Addendum No. 3

Dosker Manor Fire Alarm Replacement

FROM: Sherman Carter Barnhart Architects
2405 Harrodsburg Road
Lexington, Kentucky 40504

DATE: June 8, 2022

BUILDING B - REVISED NOTES

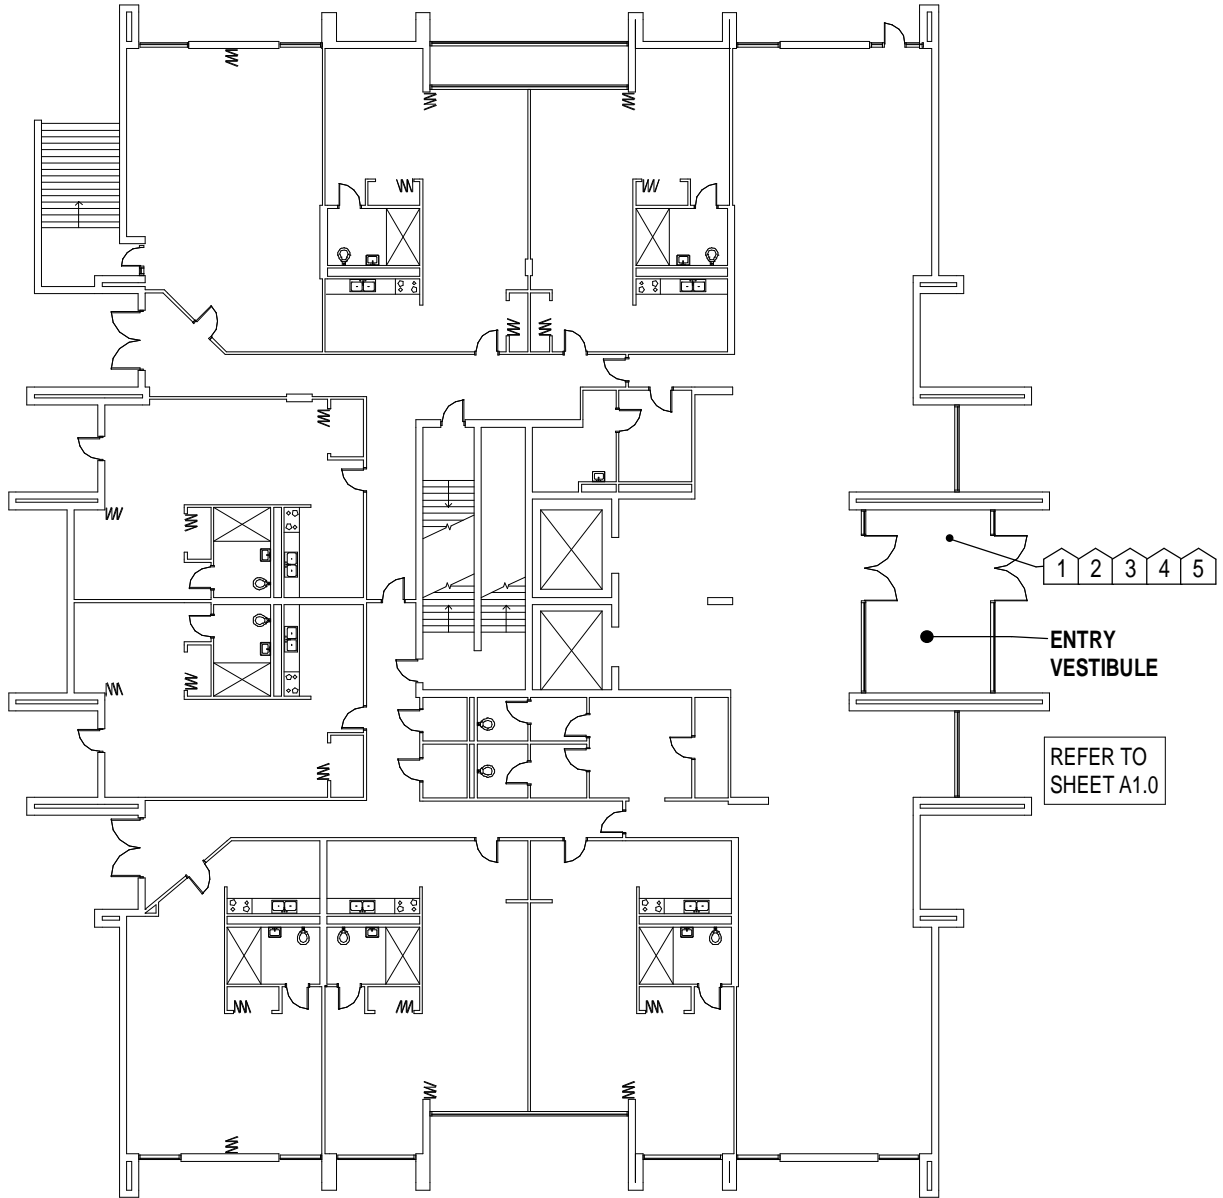
1. Sheet A1.0 – Floor Plans Buildings A, B and C and notes. Replace Plan – 3 (Building B). See attached.

FIRST FLOOR FIRE ALARM DEMOLITION PLAN - BUILDING A

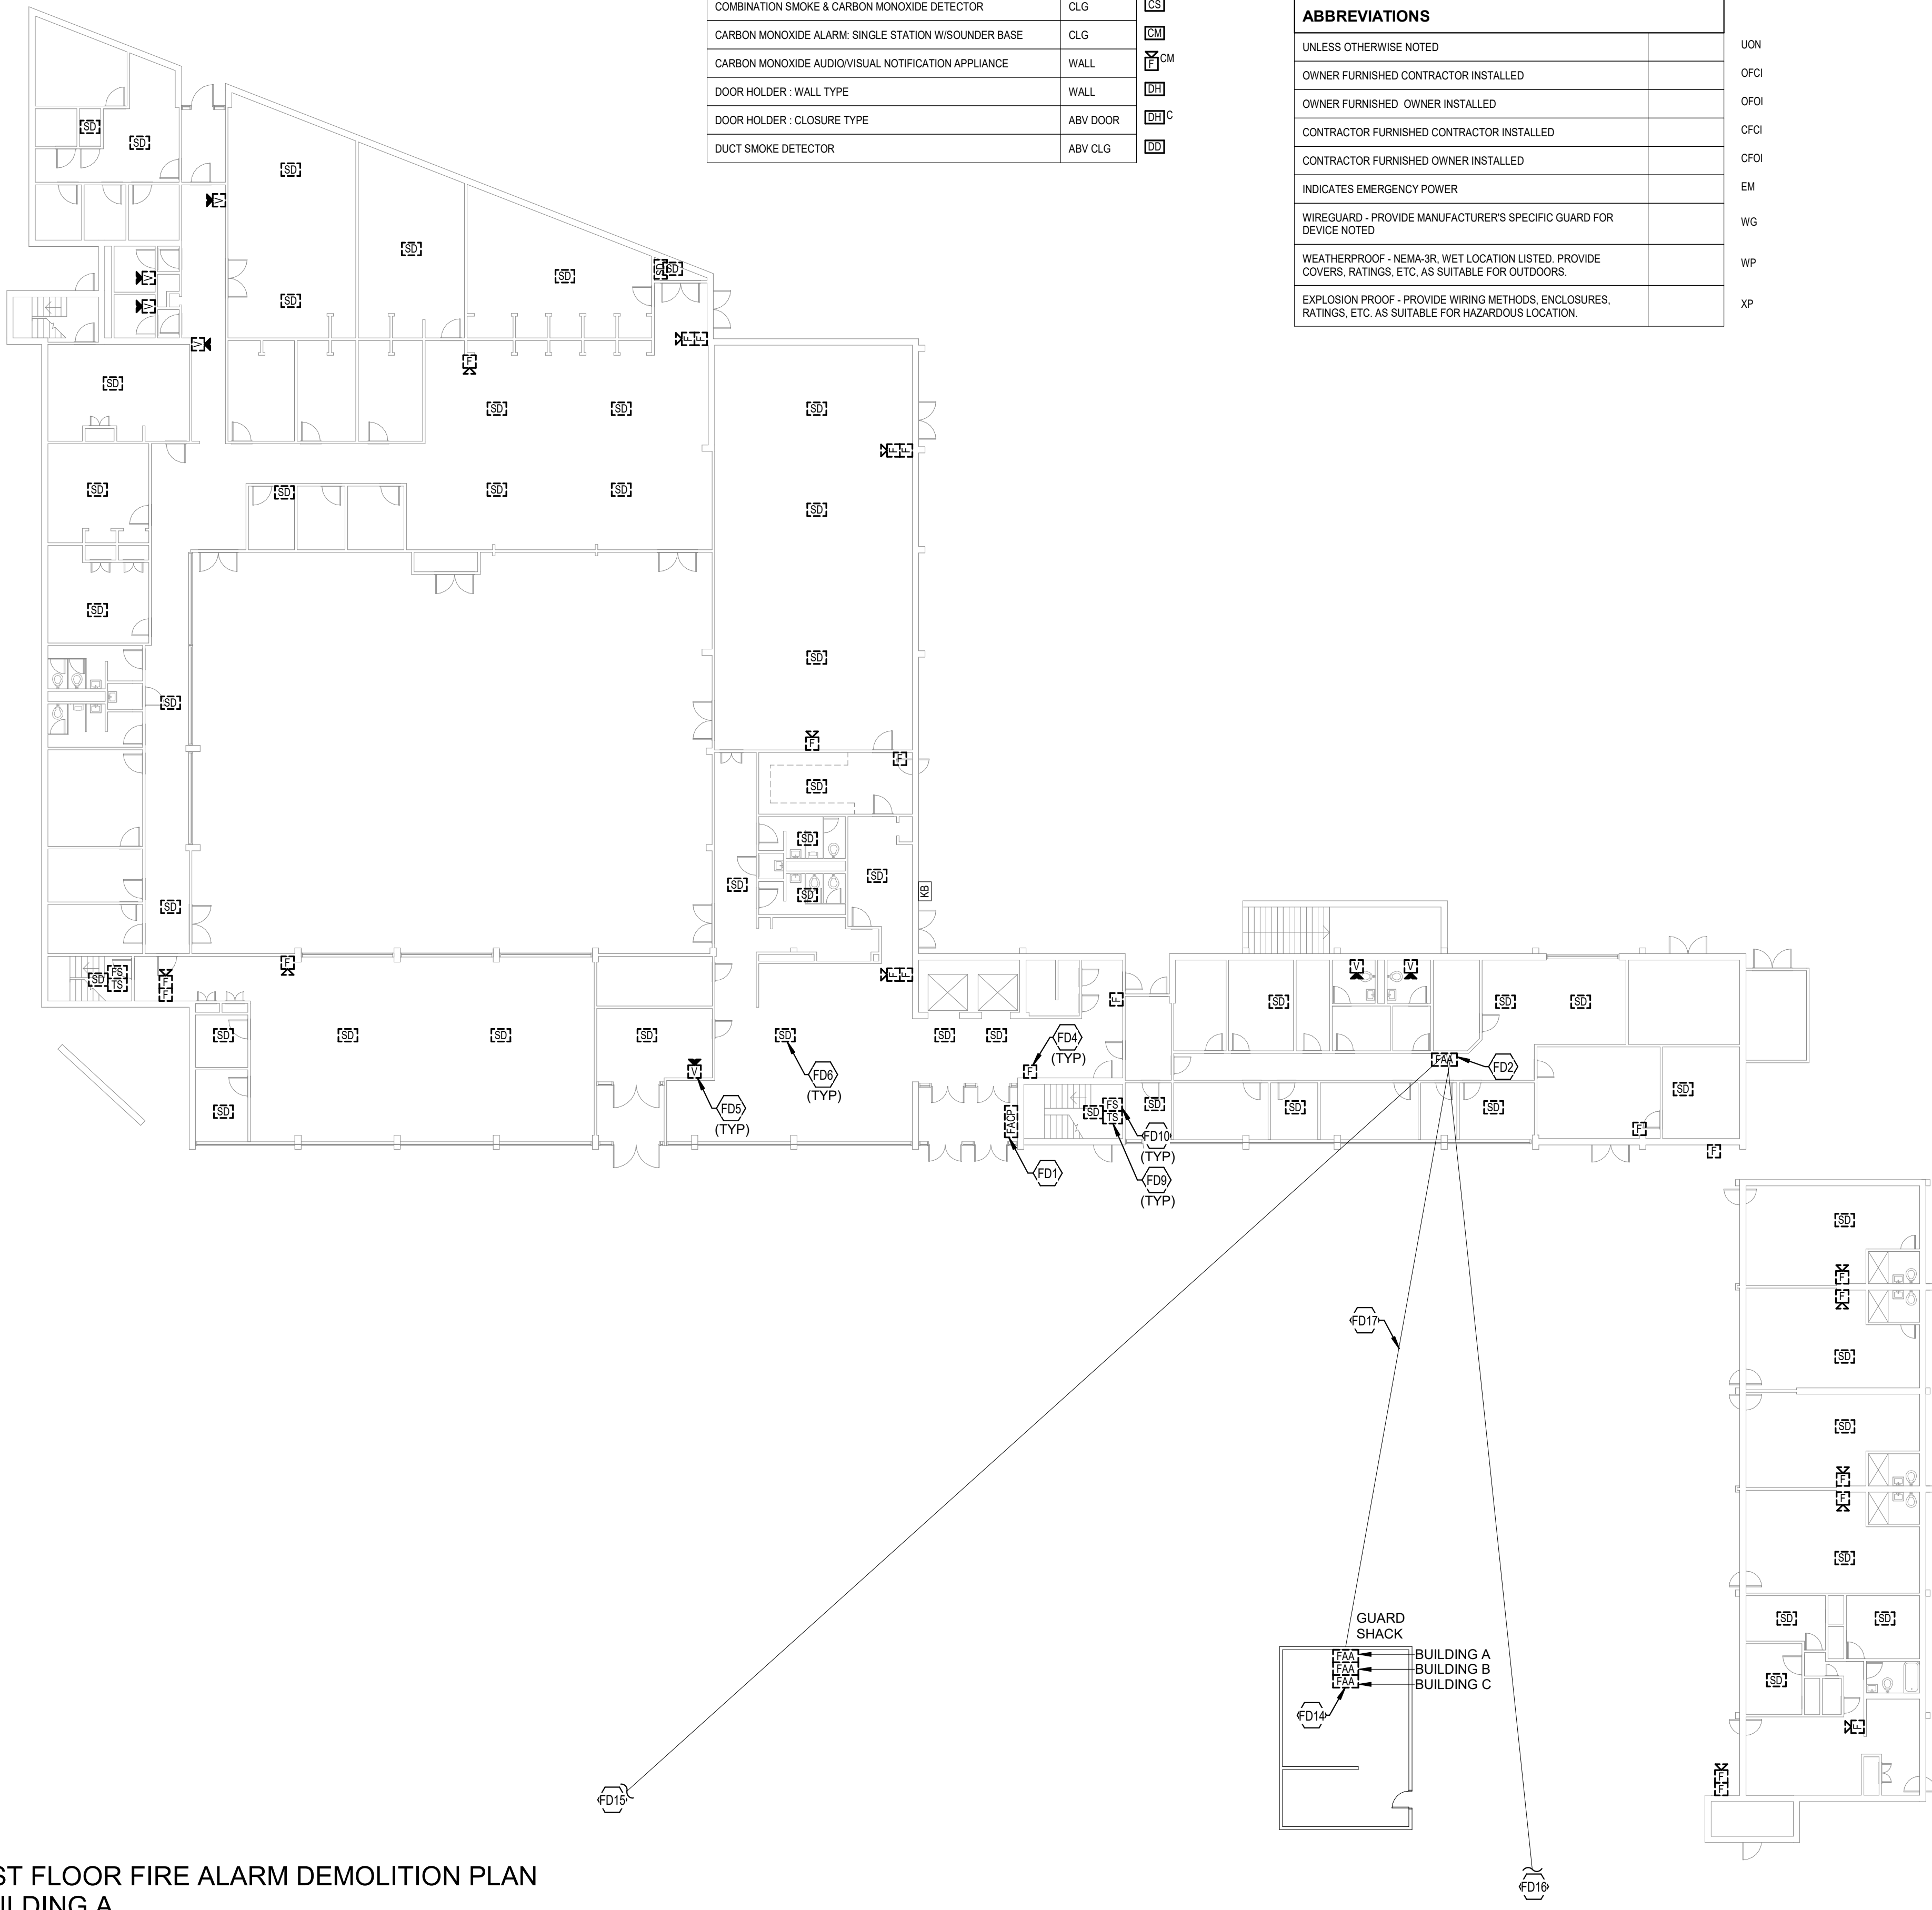
- Item #1 Refer to the Electrical Fire Alarm Notes on Sheets FAA11, FAB10, FAC11
- A. Fire alarm connections to the elevators in the buildings are in the scope of this project. Hookups are by Otis Elevator and should be coordinated in tandem with Oracle Elevators.

- B. There is no new elevator in any of these buildings. Verbiage has been removed.
 - C. There are no existing duct detectors at any of the three buildings.

- D. Firestopping note was removed as it is addressed on Sheet A1.0.
- Item #2 Refer to the Electrical General Notes on Sheets FAA21, FAB20, FAC21
- A. Mounting Heights for wall-mounted devices to comply with IECC ANSI A117.1-2009.

FIRST FLOOR FIRE ALARM NEW WORK PLAN - BUILDING A

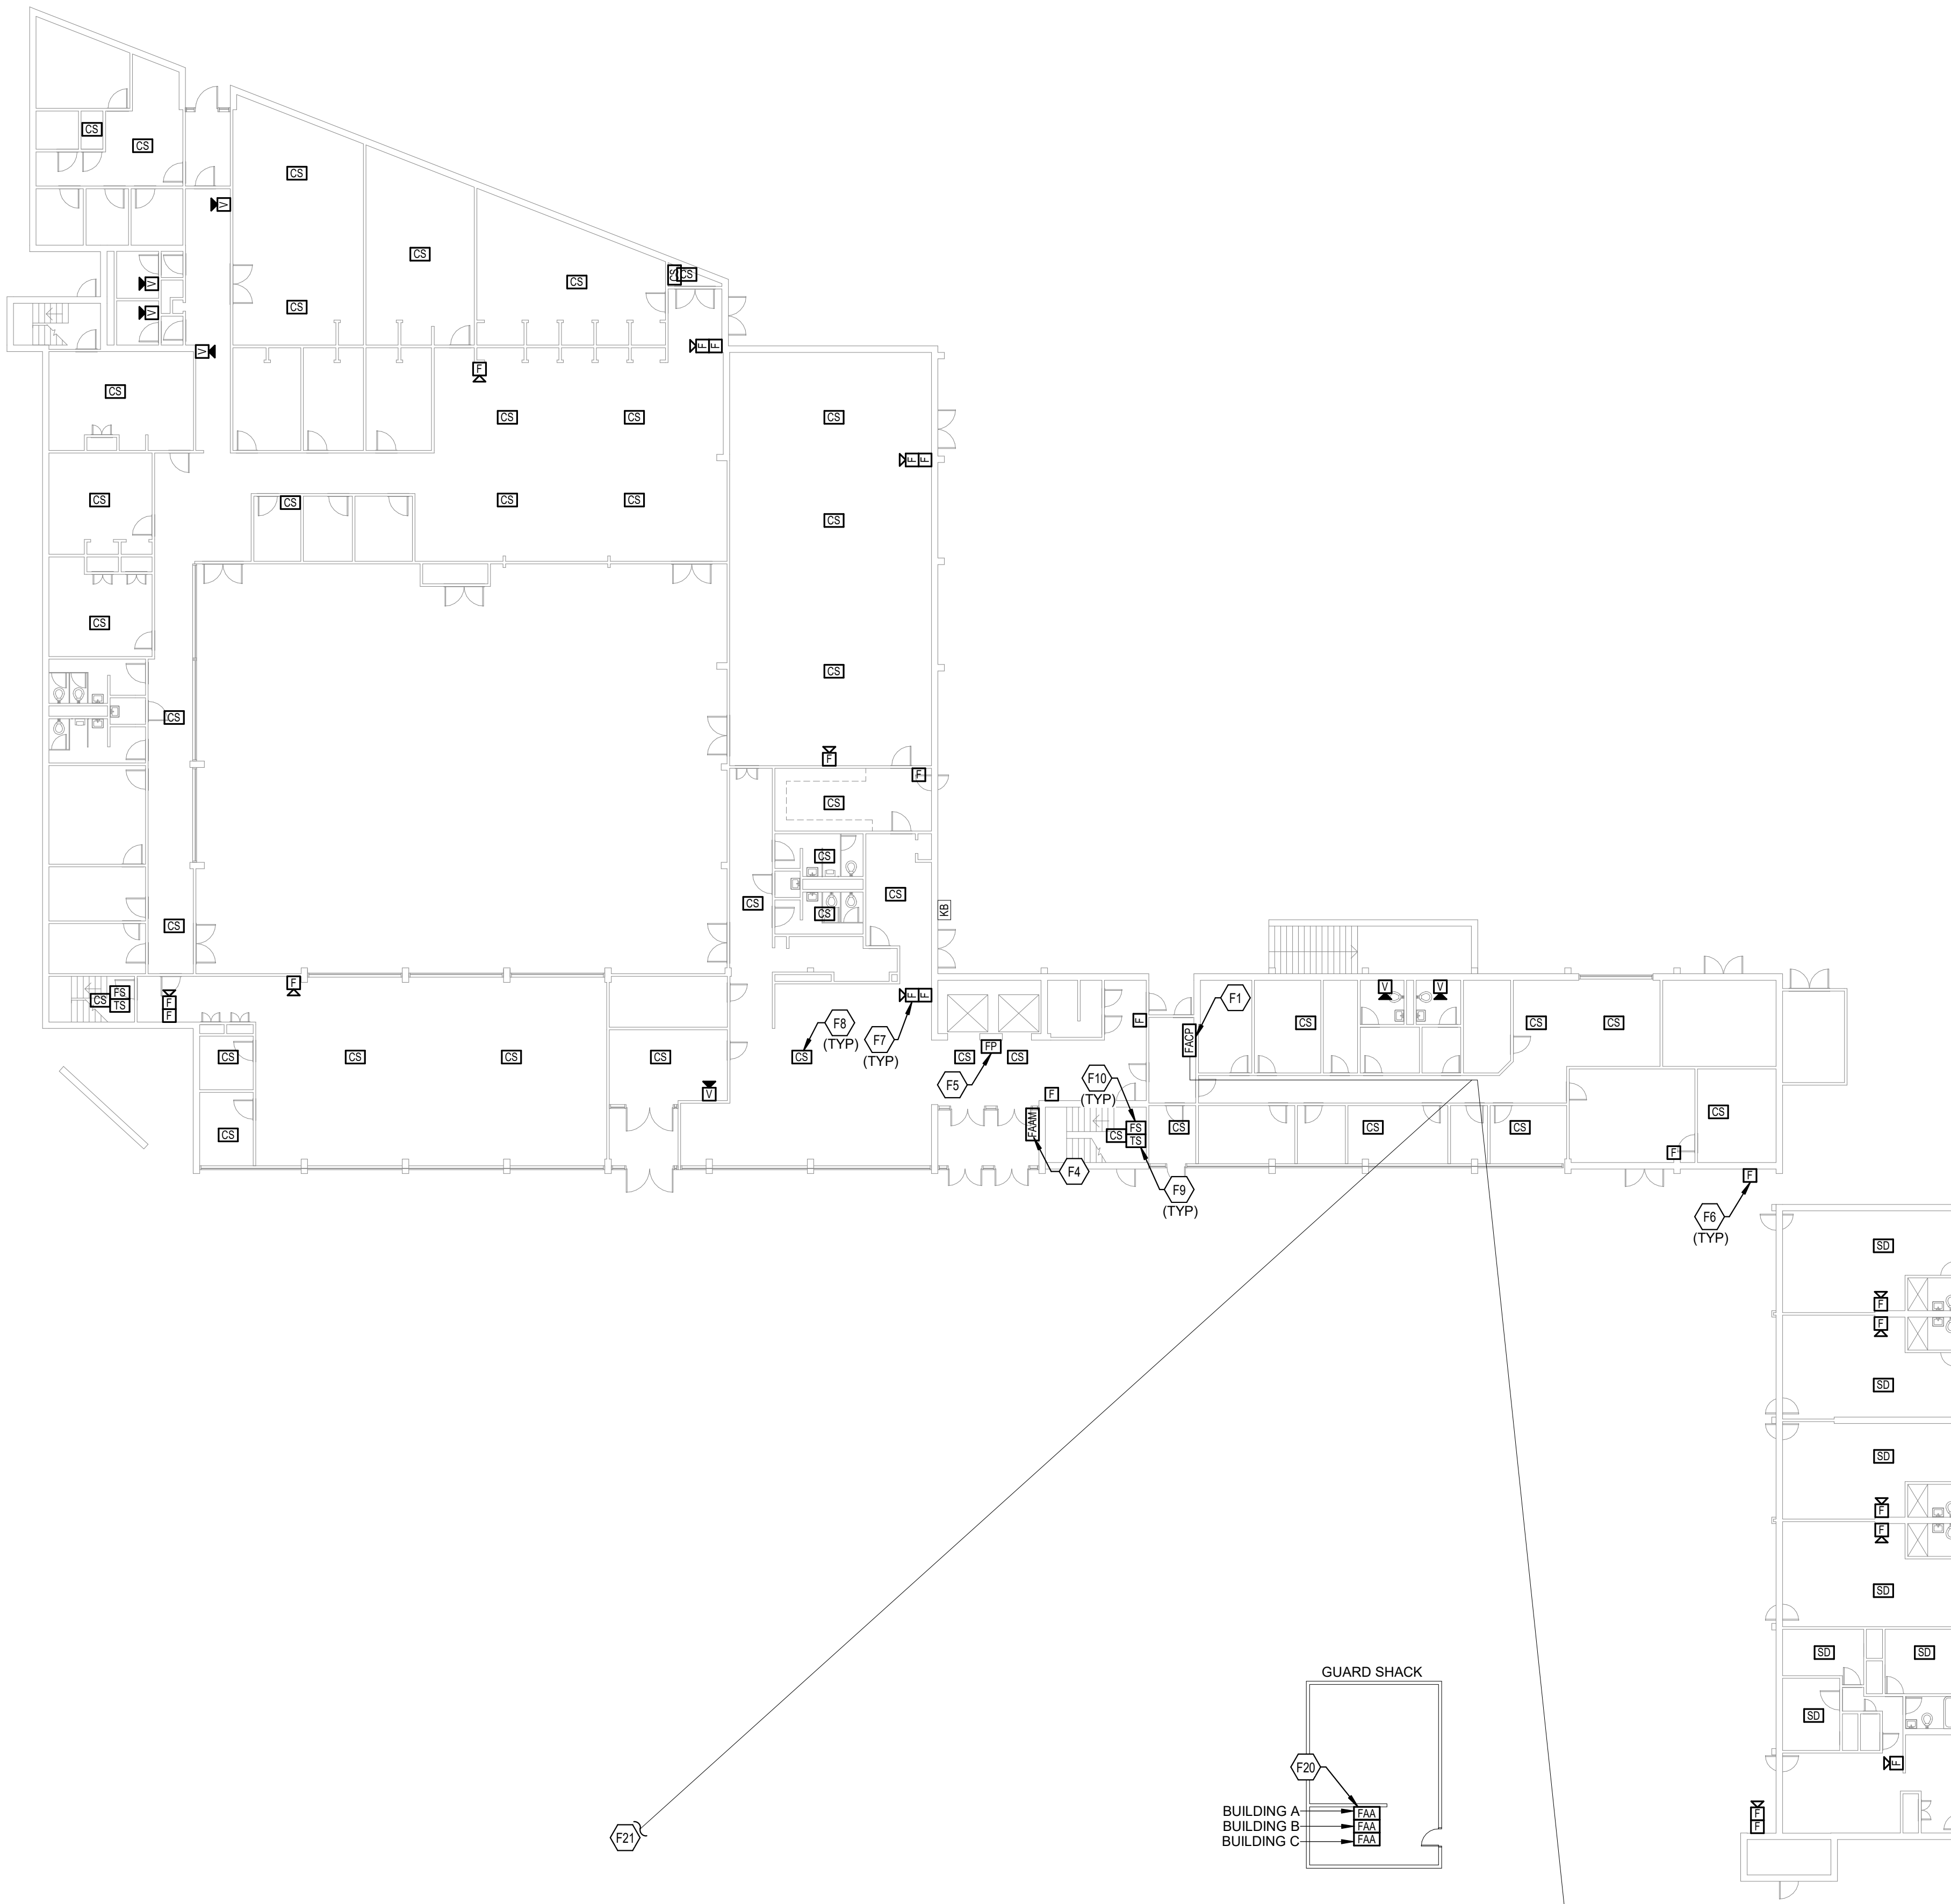
- B. Contractor to use prefinished Wiremold in lieu of painting Wiremold.
- Item #3 Refer to the Typical Wall Device Mounting Detail on Sheet FAD01
- A. Keynotes were changed from alphabetical to numerical to reflect their use on the detail.
